**CITY OF ALBANY
CITY COUNCIL AGENDA
STAFF REPORT**

SUBJECT: Resolution No. 2015-11- Marin/Curtis Intersection Safe Routes to School (SR2S) Pedestrian Improvements: Approval of Construction Plans with amendment, Contract Amendment with TJKM Transportation Consultant for Design Change and Authorize the City Manager to issue a Call for Construction Bids for the Project

SUMMARY OF NEEDED MODIFICATIONS TO THE INTERSECTION OF CURTIS STREET AND SONOMA AVENUE

RE: Change Order #1 Redesign to include Speed Hump and Raised Crosswalk

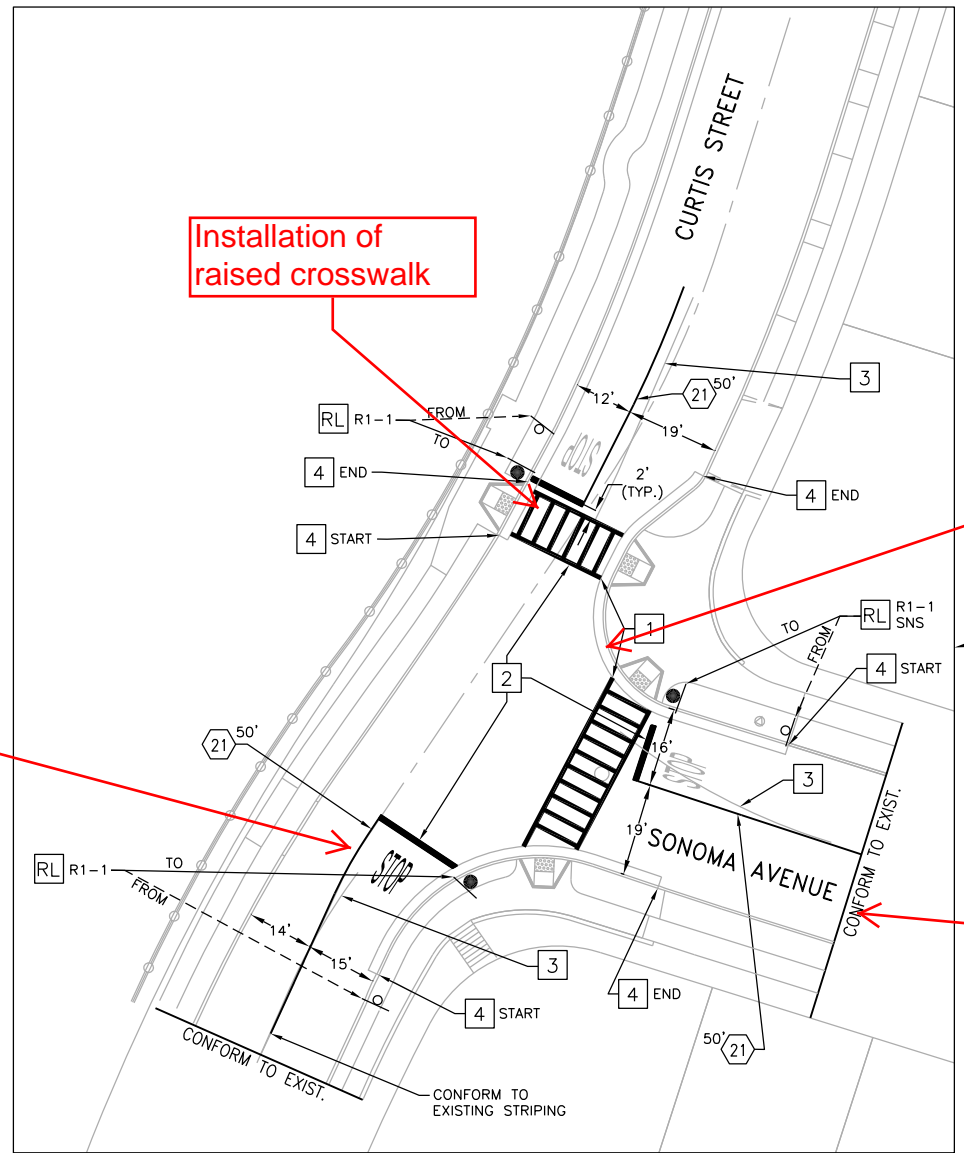
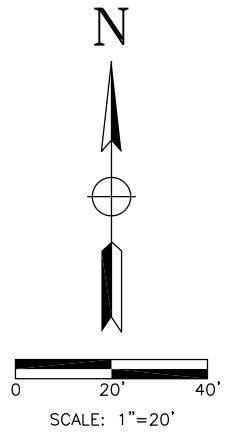
Install crosswalk and curb ramps on this leg.

Installation of raised crosswalk

Installation of a speed hump between Neilson and Peralta Avenue
